Model: OP-P2	Date: 11-Jun-14	No.: RM223001f
--------------	-----------------	----------------

Subject: Firmware Release Note: GDI		Prepared by: Y. Miyamoto	
From: 1st Tech Service Sect., MFP/Printer Tech Service Dept.			
Classification:	<input type="checkbox"/> Troubleshooting	<input type="checkbox"/> Part information	<input type="checkbox"/> Action required
	<input type="checkbox"/> Mechanical	<input type="checkbox"/> Electrical	<input type="checkbox"/> Service manual revision
	<input type="checkbox"/> Paper path	<input type="checkbox"/> Transmit/receive	<input type="checkbox"/> Retrofit information
	<input type="checkbox"/> Product Safety	<input checked="" type="checkbox"/> Other (Firmware)	<input checked="" type="checkbox"/> Tier 2

This RTB has been issued to announce the firmware release information for **GDI SFP (SP 210, 211)**.

4. Replacement and Adjustments > Boards > After Replacing the Main Board

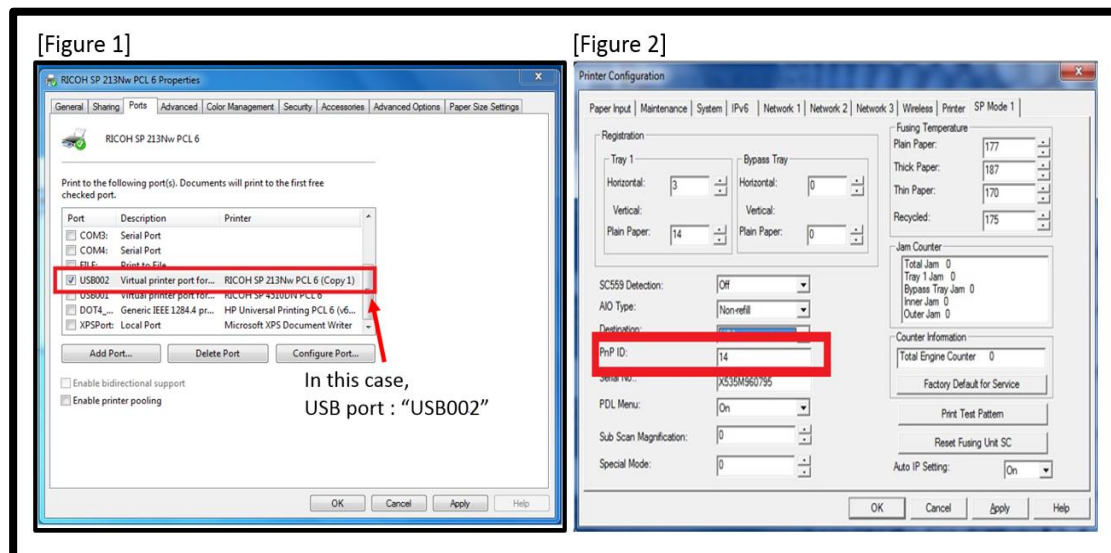
Procedure for replacing the Main Board was corrected.

- Install the printer driver and SOM.
- Create a USB port for the printer. (Figure 1 below)
- Verify the PnP ID of the printer. (Figure 2 below)

1. Turn OFF the device and replace the main board with a new one.
2. Turn ON the device.
3. Connect SOM to the device with a USB cable.
4. Verify that the port is identical to that created in the preparation step (Figure 1 above). If not, correct the port.
5. Type in the PnP ID verified in the preparation step (Figure 2 above).
6. Reboot.
